COMMITTEE OF ADJUSTMENT

MINOR VARIANCE REPORT

APPLICATION: **CAV A/193/2022**

CAV A/193/2022 - 131 Mayfield Dr (West District) (OP Designation: Low Density Residential))

Excerpt from the Site Plan:

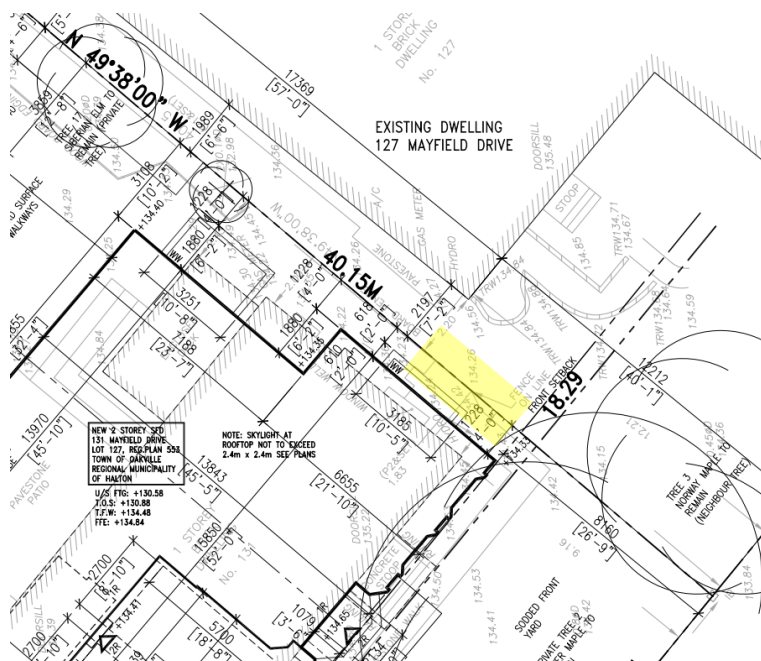
Variance #1: Window Well Encroachment (Unsupported)

The applicant is seeking relief from Zoning By-law 2014-04, as amended, to permit a increase in the window well width from 1.8 m to 3.185 m into the minimum side yard. The intent of regulating window wells is to allow for adequate side yard drainage, access and allows for landscaping. In this instance, the increased width has the potential to impact grading in the area and can cause potential flooding onto the adjacent property due to drainage issues. In this instance, the increased length of the window well has the potential to impact grading in the area and reduce the opportunity for an appropriateability swale in the side yard. Staff are of the opinion that the requested variance is not minor in nature and does not meet the intent of the Zoning By-law and Official Plan.

Excerpt from the Second Floor plan by the applicant

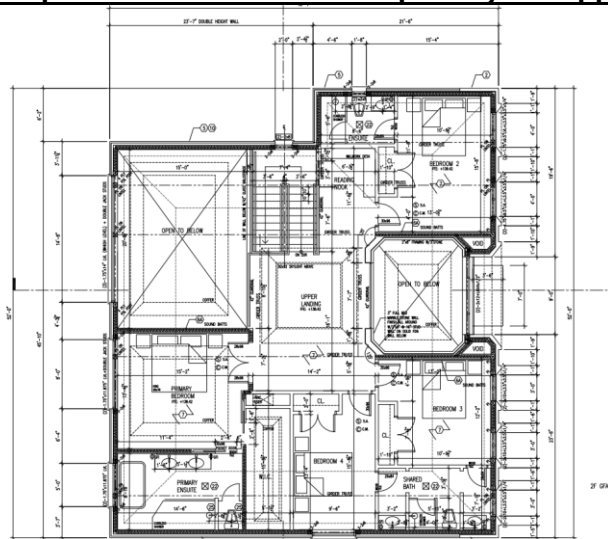
Variance #2: Residential Floor Area (Unsupported)

The applicant is requesting relief from Zoning By-law 2014-014, as amended, to permit an increase in the maximum residential floor area ratio from 41% (301.01 square metres) to 43.69% (320.75 square metres) for an increase of 19.74 square metres. The intent of regulating the residential floor area is to prevent a dwelling from having a mass and scale that appears larger than the dwellings in the surrounding neighbourhood. The proposed dwelling also includes large open to below areas. The open to below area serves to push the second storey floor area to the perimeter of the dwelling which would create a mass and scale that would be considered an over building on the lot. Staff are of the opinion that a variance for residential floor area ratio is interrelated to the height variance and it is not minor in nature.
